## Errata

This errata sheet is for MB90820B Series Hardware Manual Rev. 2\_(CM44-10147-2E).

F<sup>2</sup>MC-16LX  
16-BIT MICROCONTROLLER  
MB90820B Series  
HARDWARE MANUAL

2012.12.7

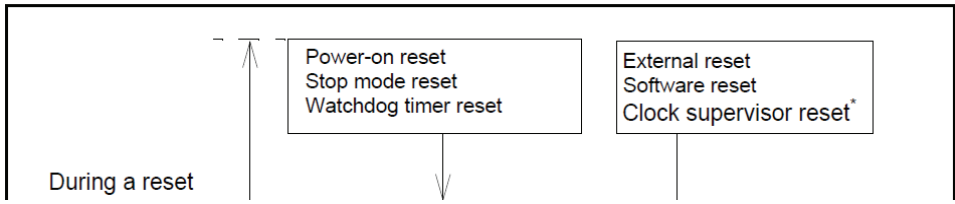
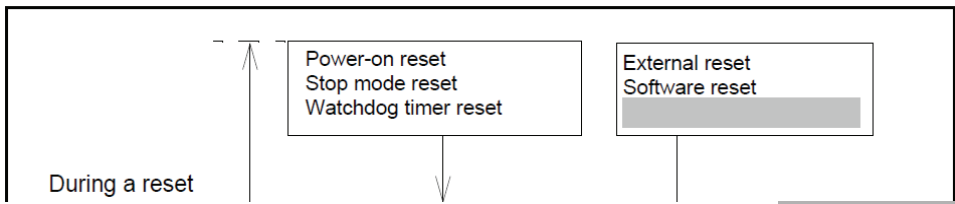
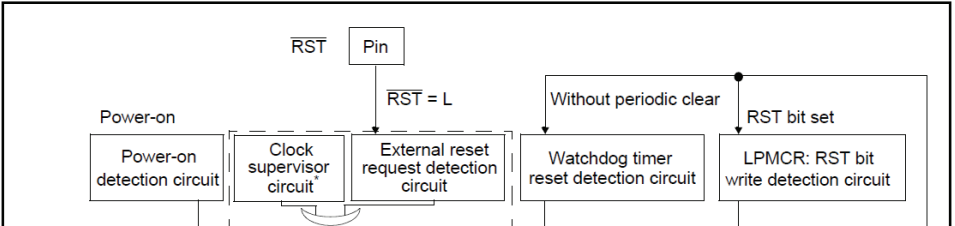
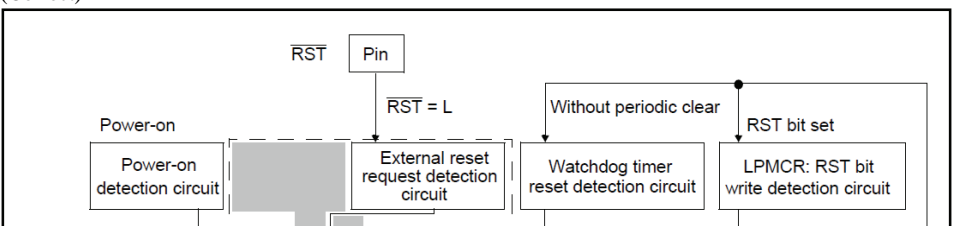
Date	Page	Item	Description												
2012/12/7	4	1.1	"● Clock supervisor" of "■ Internal Peripheral Features" should be deleted. <span style="float: right;">[mcu_doc1192]</span>												
2012/12/7	5,6	1.2	"MB90F828B" row of "Table 1.2-1 MB90820B Series Product Line-up" should be deleted. <span style="float: right;">[mcu_doc1192]</span>												
2012/12/7	5	1.2	"Clock supervisor"Line of "Table 1.2-1 MB90820B Series Product Line-up" should be deleted. <span style="float: right;">[mcu_doc1192]</span>												
2012/12/7	7	1.3	<p>"Figure 1.3-1 MB90820B Series Overall Block Diagram" should be corrected as indicated by the shading below.</p> <p>(Error)</p>  <p>*1: High current drive pin. *2: MB90F828B</p> <p>(Correct)</p>  <p>*1: High current drive pin.</p> <p style="text-align: right;">[mcu_doc1192]</p>												
2012/12/7	29	2.3	<p>"Figure 2.3-1 Memory Maps" should be deleted as indicated by the shading below.</p>
